Access Compliance Report Public Rights-of-Way (Curb Ramps)

Main Street: WASHINGTON_AVE Cross Street: JACKSON_ST Location: NW

ADA ID: RPRK210930150751 Ramp Type: Type 1 - Perpendicular Diagonal Initial Pass/Fail: Fail Overall Compliance: No Severity Score: 20

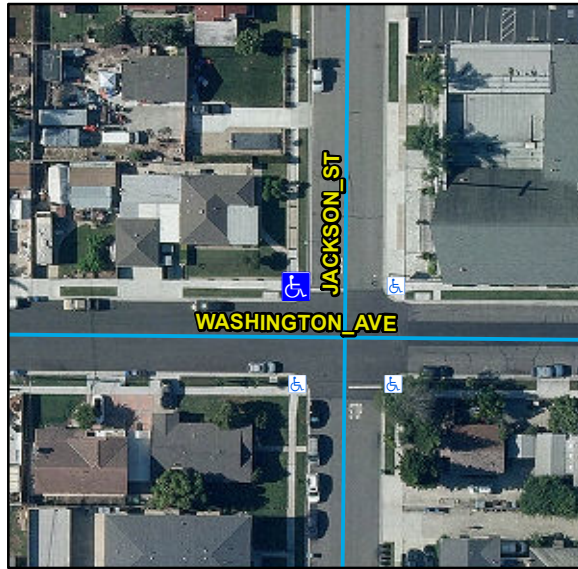
R304.2.2, R204.3, R304.5.1, R304.5.3, STD 1115

Compliance	Description	Data	Compliance	Description	Data
N/A	Ramp Length (in)	102	N/A	Flare Type LT	
No	Ramp Width (in)	36			N/A
No	Ramp Run Slope (%)	9.6	N/A	Flare Slope LT (%)	N/A
No	Ramp Cross Slope (%)	3.7	N/A	Flare Traversable LT	N/A
N/A	Landing Present	N/A	N/A	Flare Type RT	
N/A	Landing Length (in)	N/A			N/A
N/A	Landing Width (in)	N/A	N/A	Flare Slope RT (%)	N/A
N/A	Landing Run Slope (%)	N/A	N/A	Flare Traversable RT	N/A
N/A	Landing Cross Slope (%)	N/A	N/A	DWS Provided	N/A
N/A	Landing Movement Obstructed?	N/A	N/A	DWS Contrast	N/A
	Landing Movement Type	N/A	N/A	DWS Length (in)	N/A
N/A	Landing Shared	N/A	N/A	DWS Full Width	N/A
N/A	Clear Space	Yes	N/A	DWS Offset Left (in)	N/A
N/A	Clear Space To Crosswalk (in)	N/A	N/A	DWS Offset Right (in)	N/A
N/A	Marked Crosswalk 1	No	N/A	Marked Crosswalk 2	No
	Crossing 1 Direction	S		Crossing 2 Direction	E
	Marked Crosswalk 1 Width (in)	N/A		Marked Crosswalk 2 Width (in)	N/A

Remove & Replace Curb Ramp With Two New Directional Ramps or Equivalent.
